PRODUCT CHANGE NOTIFICATION

Bourns® Model SRU3028-100M, SRU3028-100MH and SRU3028A Series Shielded Power Inductors

Manufacturing Site Relocation and Changes to Processes and Ink Supplier

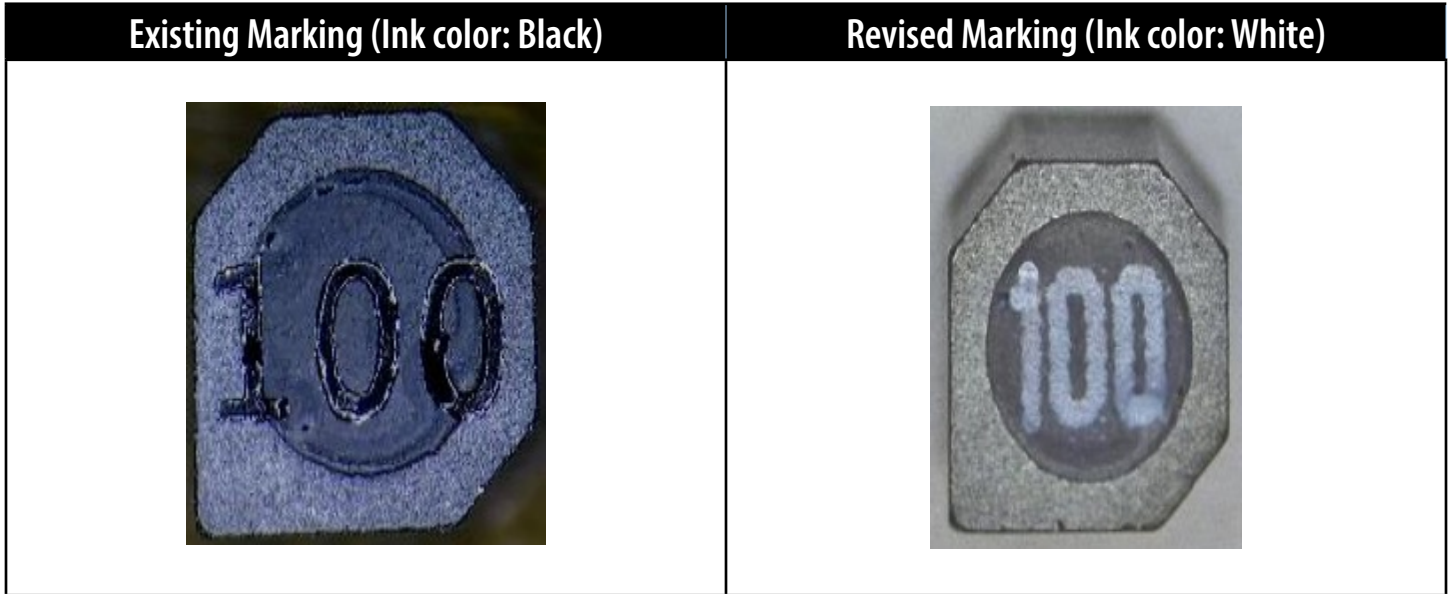
Bourns will also change the soldering process from manual to semi-automated, the marking process from manual screen printing to an automated inkjet printing process, and also change the color and supplier of the ink. These changes should improve production efficiency, product quality and reliability. The new supplier has been qualified and is included in the Bourns Authorized Vendor List. A list of affected part numbers is included below.

As shown in the images above, the form will change slightly due to the changes in the marking process and ink. The fit, function, and country of origin of the affected part numbers will remain the same. The quality and reliability of the affected part numbers should be improved by the automated process changes. Traceability will be maintained through lot code and date code.
